ADDENDUM A Staff Report: Z-SP-3-25-6

Proposal: Self-Service Storage Warehouse

Location: Northeast corner of 17th Street and

The purpose of this addendum is to revise the language for Stipulation No. 1 to reflect updated elevations submitted by the applicant.

Elevations date stamped August 18, 2025

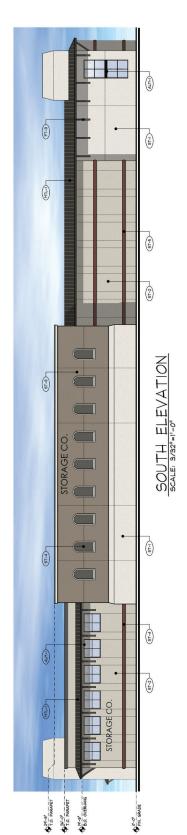
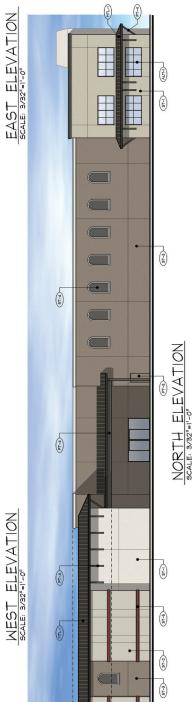
The North Mountain Village Planning Committee is scheduled to hear this case on August 20, 2025. On August 18, 2025, the applicant submitted revised elevations to reflect ongoing discussions with community members. The revised elevations depict a color scheme that contains natural earth tones. Staff recommends modifying Stipulation No. 1 to reflect the new submittal date and to ensure the elevations develop as proposed.

- 1. The development shall be in general conformance with the site plan and elevations date stamped May 27, 2025, AND THE ELEVATIONS DATE STAMPED AUGUST 18, 2025, WITH SPECIFIC REGARD TO THE COLOR PALETTE, as modified by the following stipulations and approved by the Planning and Development Department.
